**PLANNING BOARD
PORTSMOUTH, NEW HAMPSHIRE**

November 16, 2023

To: Planning Board
From: Peter Stith, Planning Manager
Date: November 15, 2023
Re: Recommendations for the November 15, 2023 Planning Board Meeting

- A. The request of **Lonza Biologics (Owner)**, for property located at **101 International Drive** requesting Amended Site Plan approval for Phase 2 which includes fit-up of Building #1 and the utility building, construction of a temporary surface parking lot and gravel area for construction trailers, parking and laydown area in the location of Proposed Building #2. Said property is located on Assessor Map 305 Lot 6 and lies within the Airport Business Commercial (ABC) District. (LU-23-108)

C-163.1

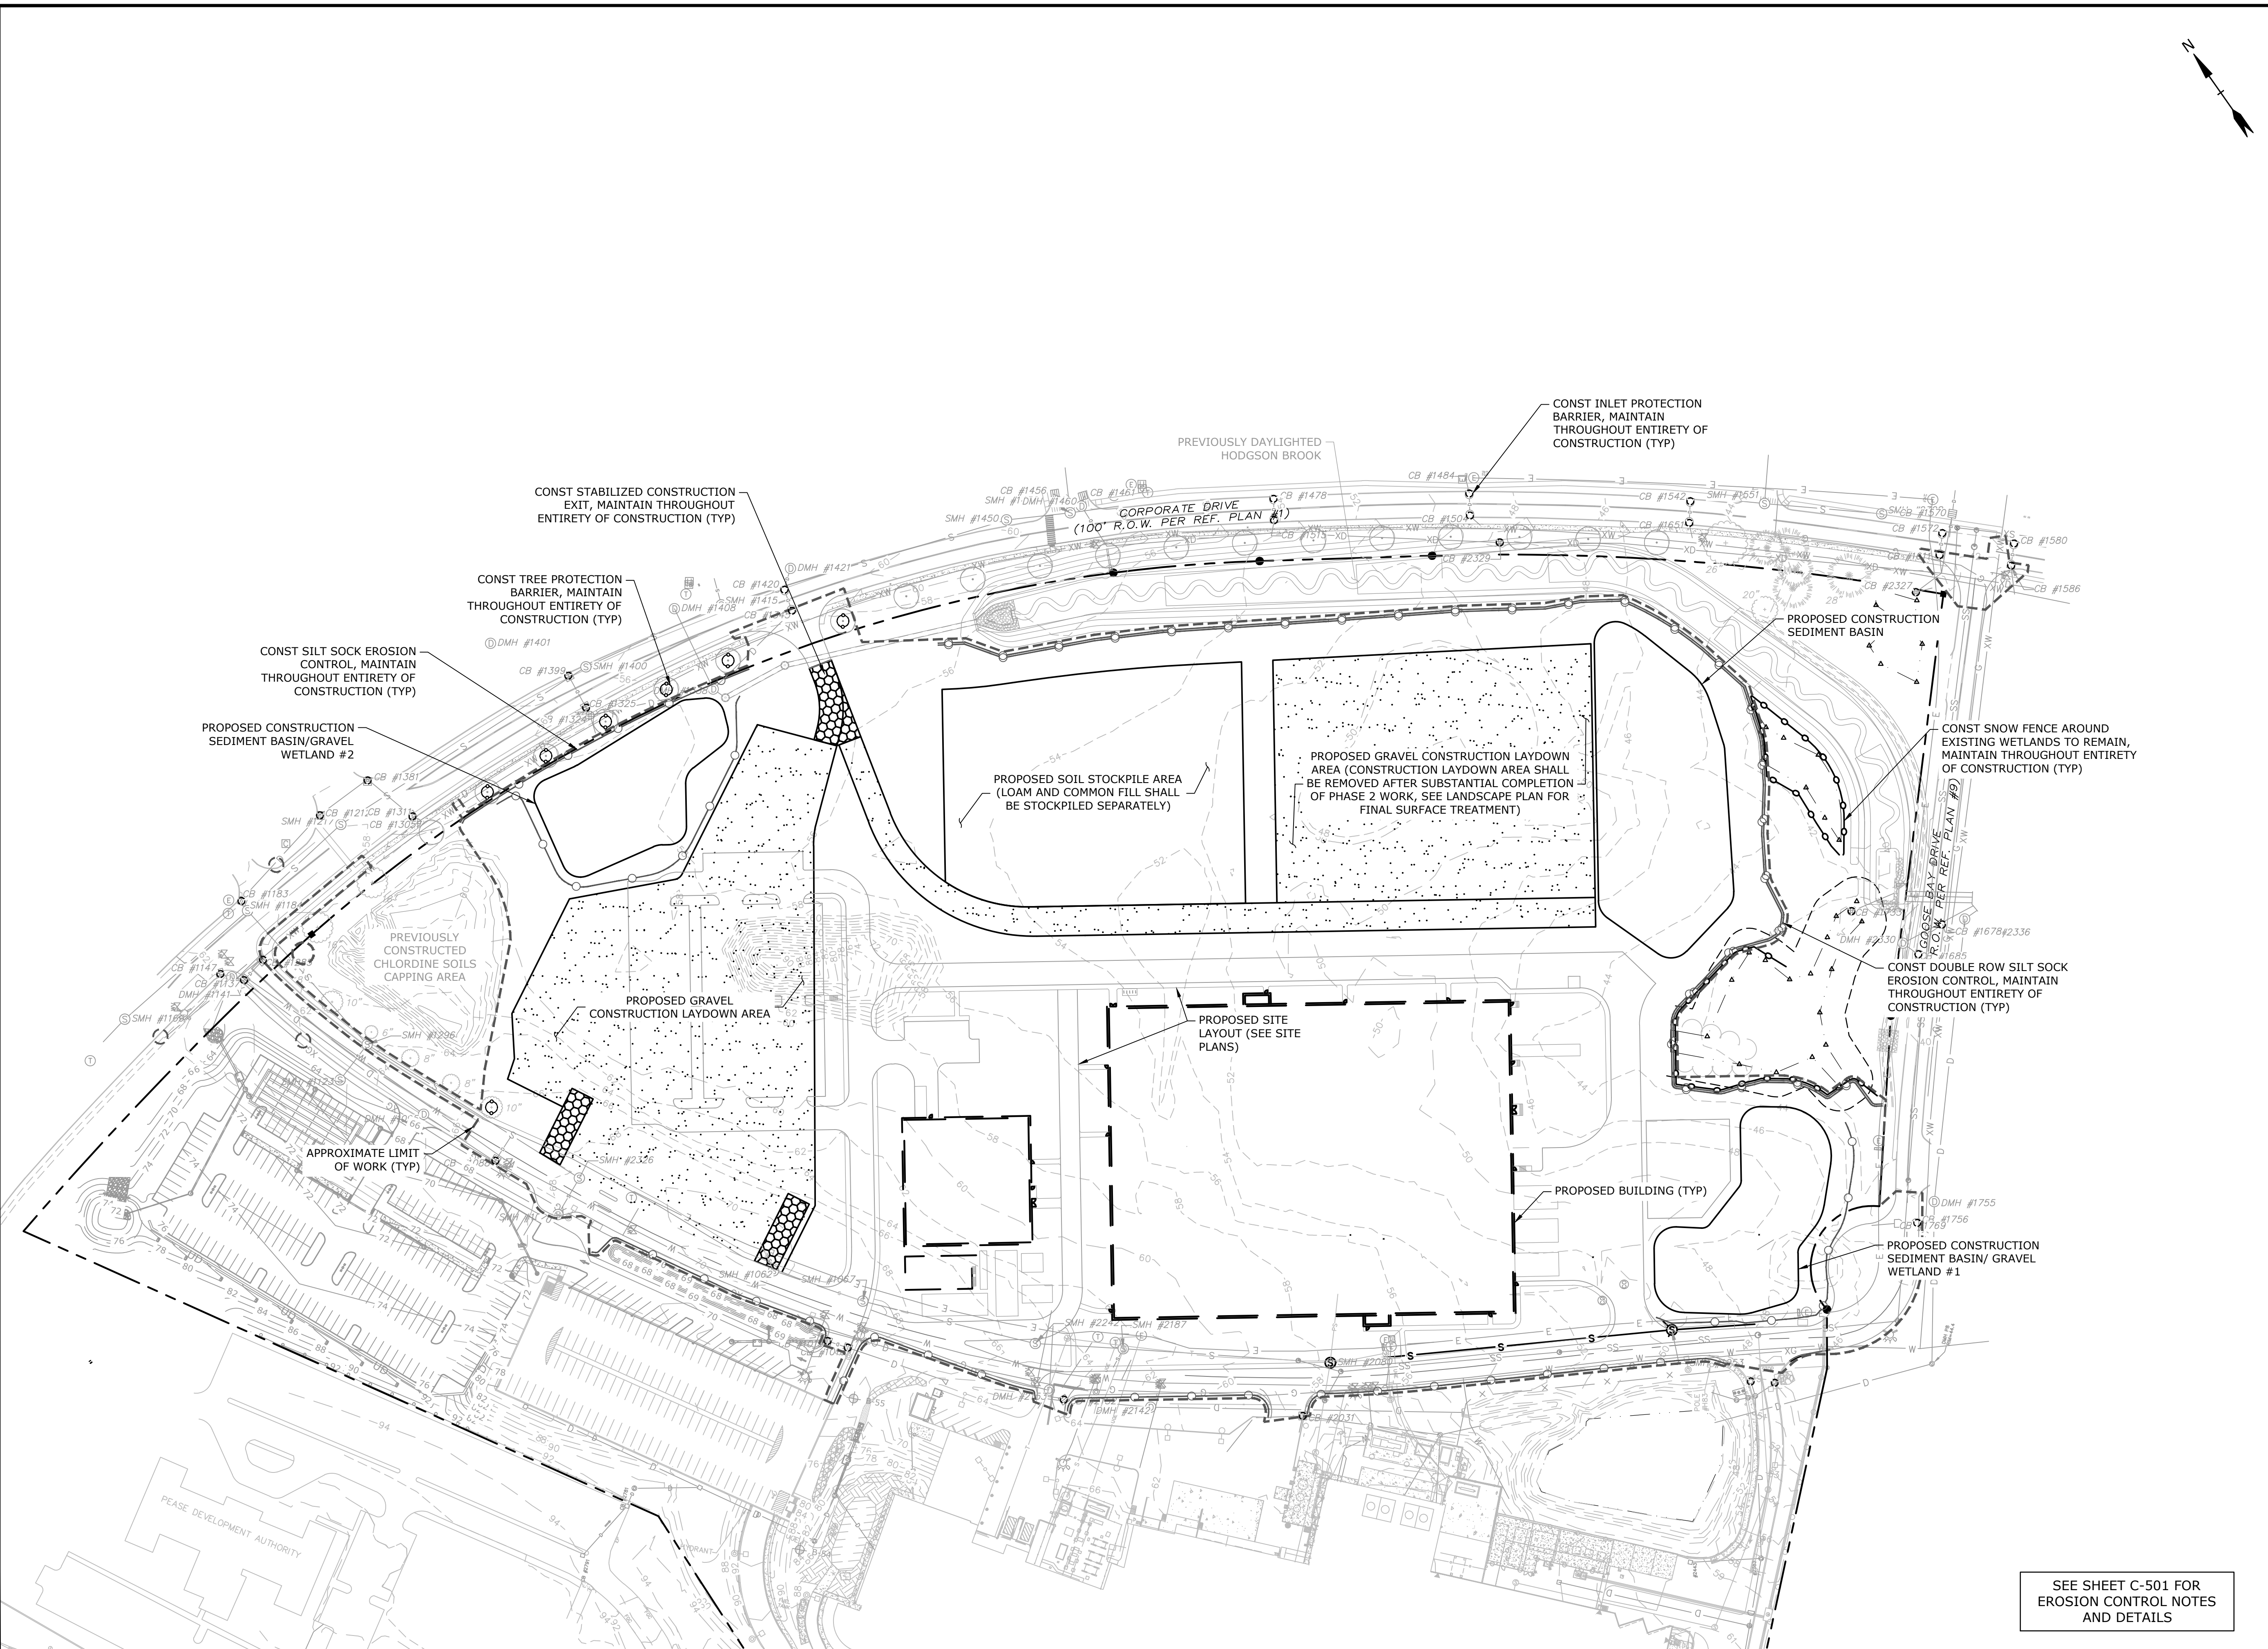
Sheet C-163.1 shows the location of the gravel construction laydown area in the location of building #2. Confirmed the intent is for the laydown area to be removed at the completion of Phase 2 for the planting of the lawn as provided in Landscape Plan C-175 and 176.

C-165

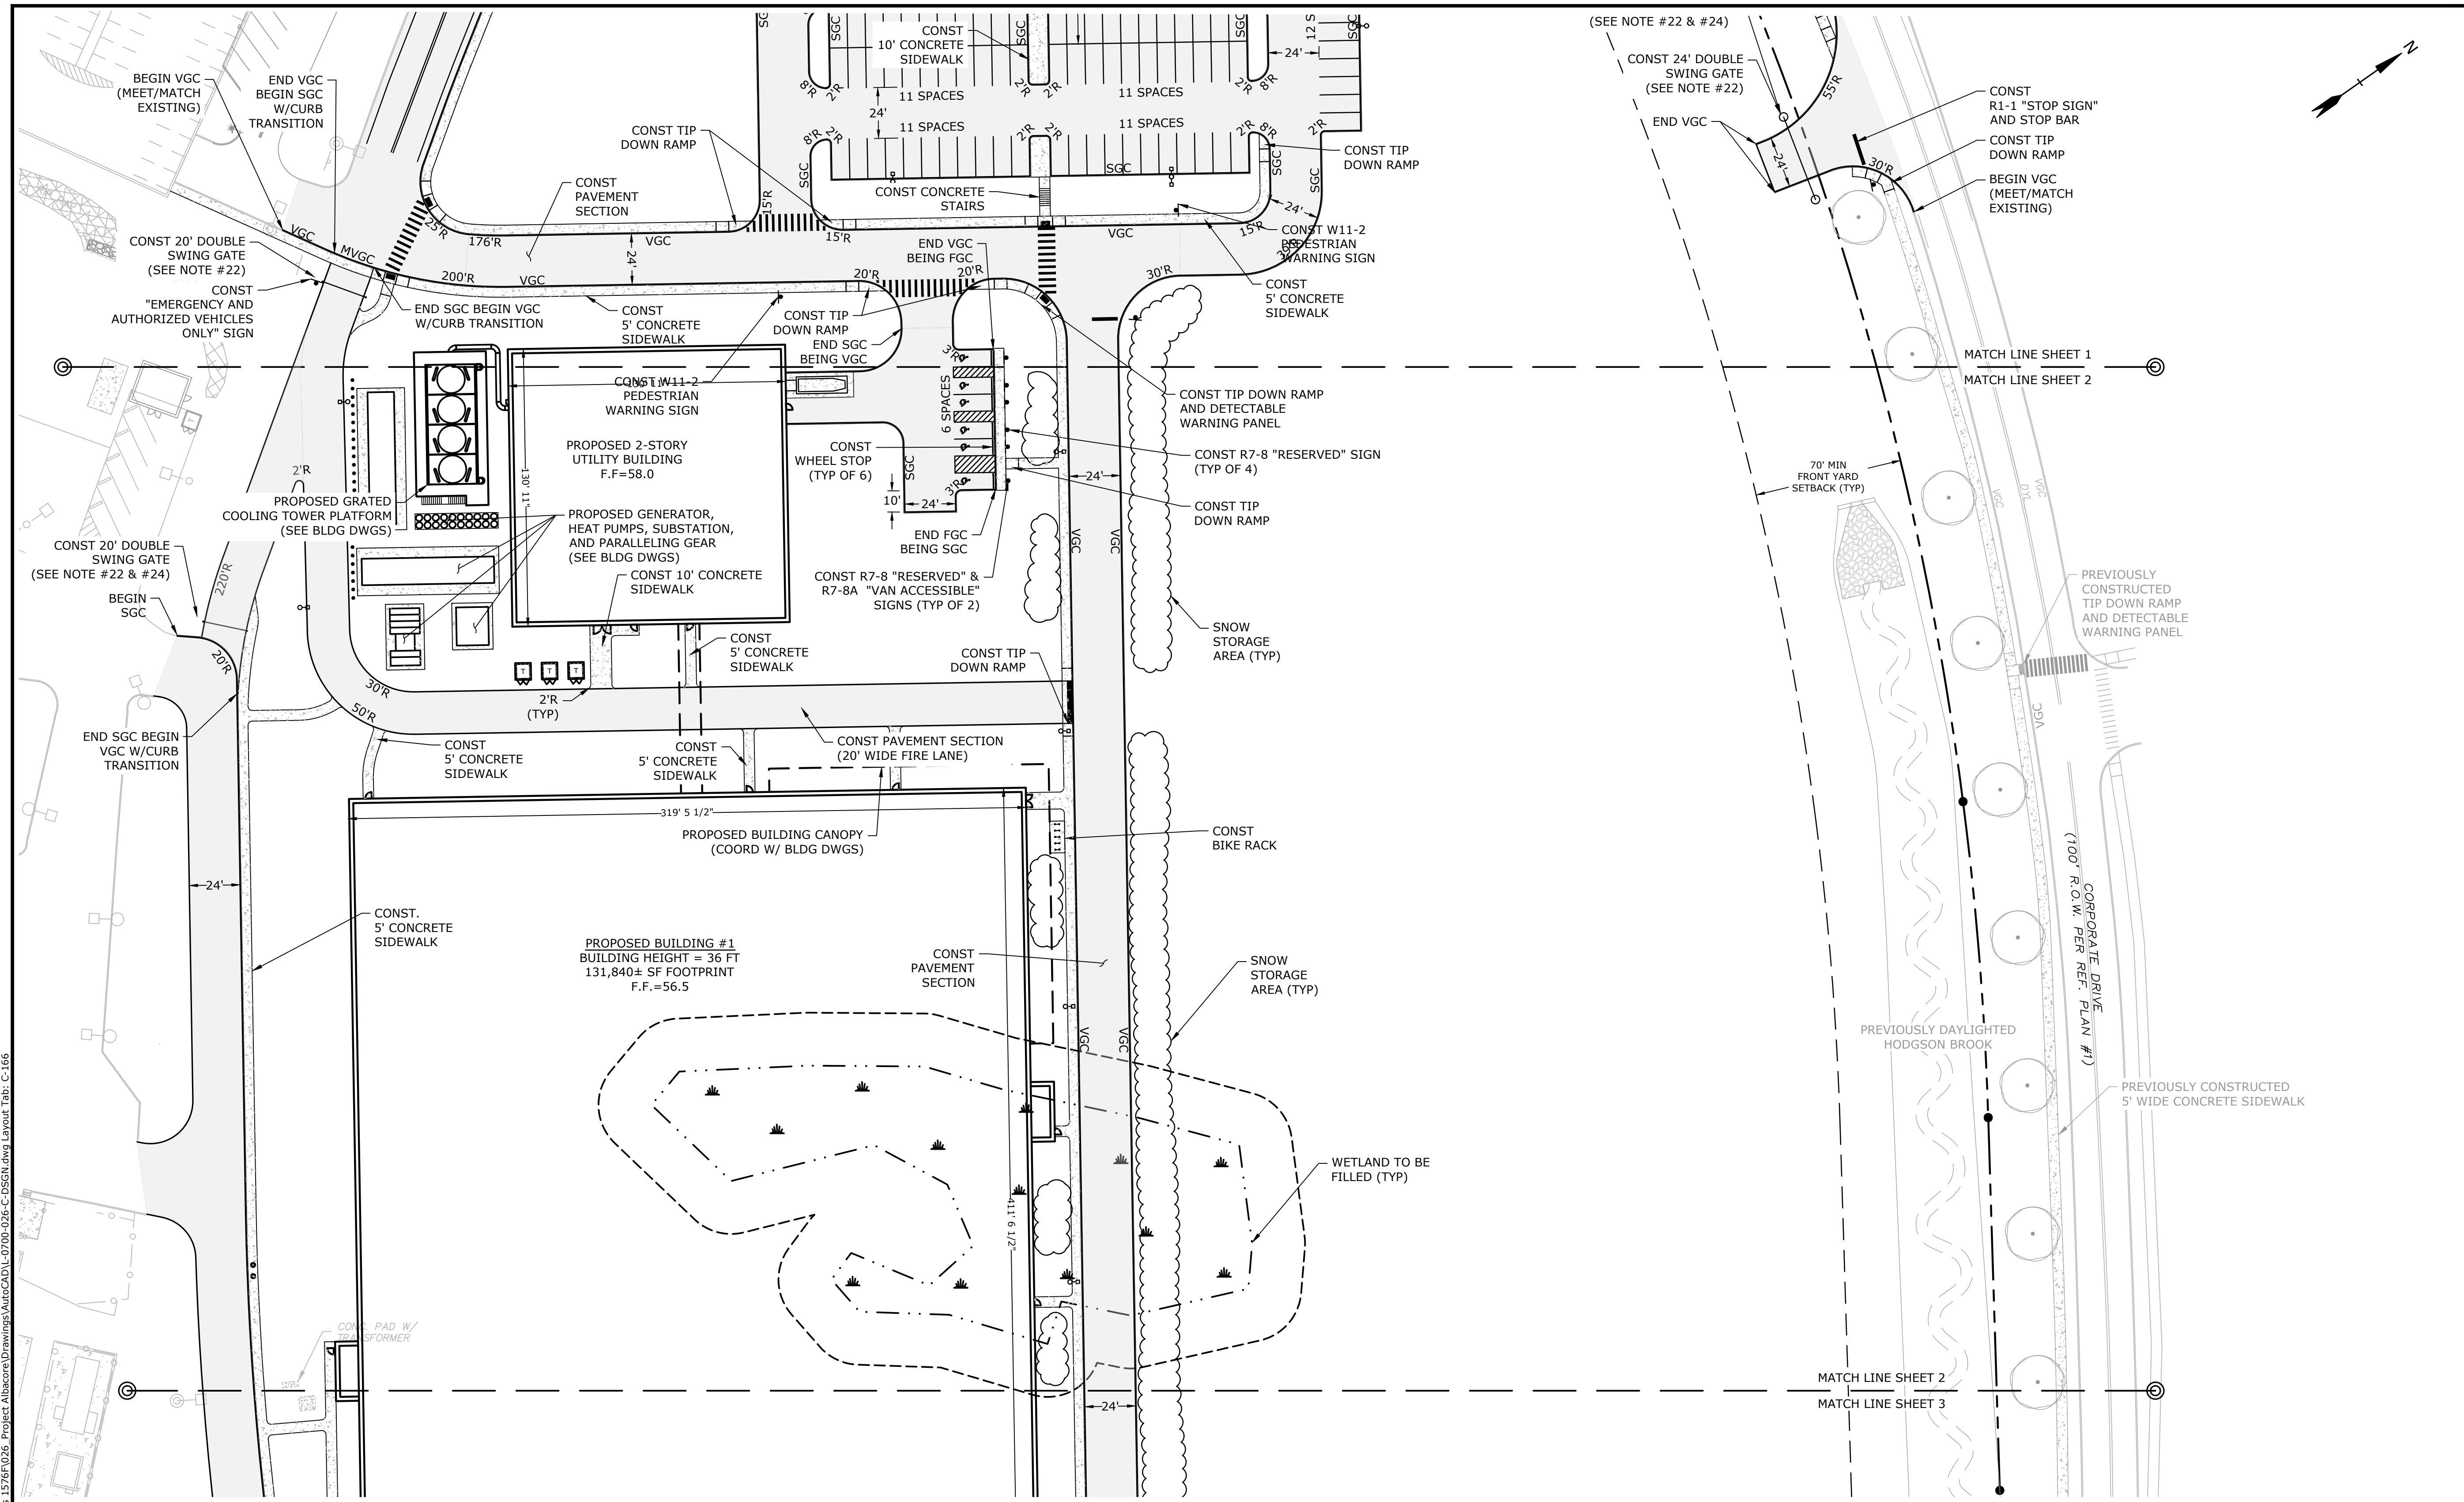
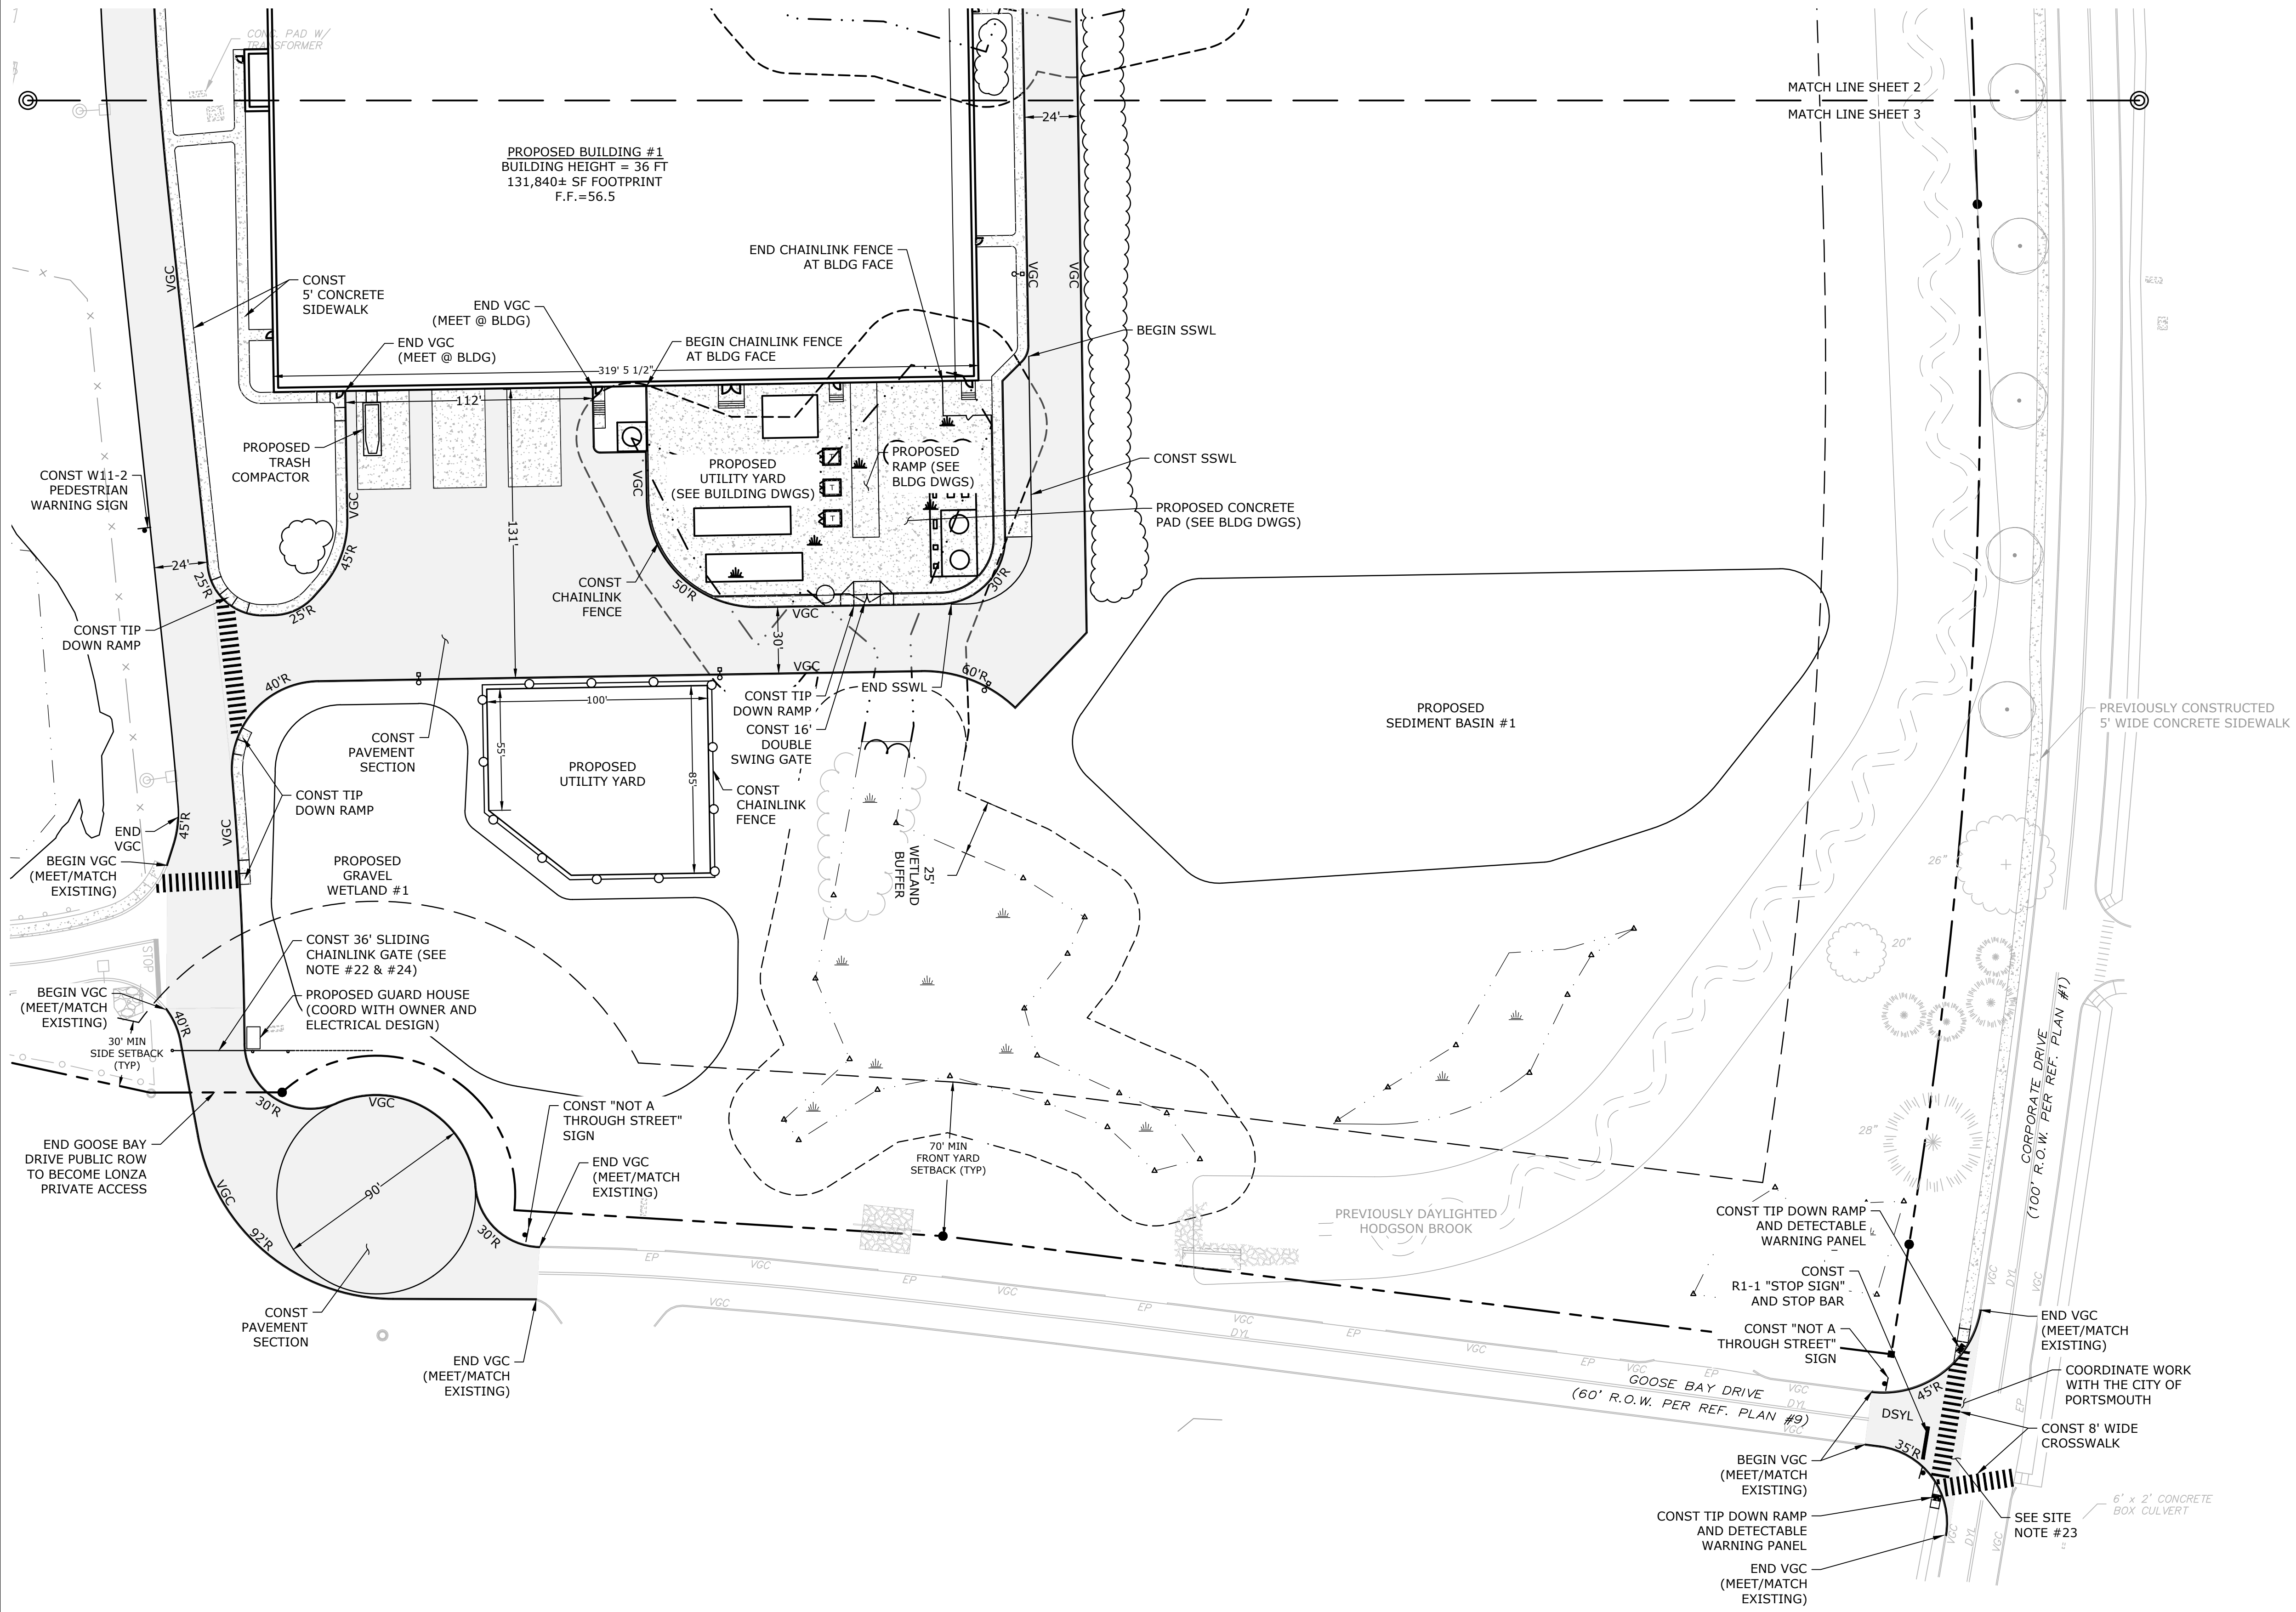
- A central sidewalk has been added through the 150 space parking area connecting to the currently proposed sidewalk. (Sheet C-165)
- A second trash compactor has been added to the site adjacent to the Utility Building. Truck turning was studied to confirm access. (Sheet C-166)
- Pedestrian warning signs have been added to the plans as recommended. (Sheets C-165, C-167 & C-502)
- Crosswalk Striping detail has been revised to note an 8' width. (Sheet C-502)
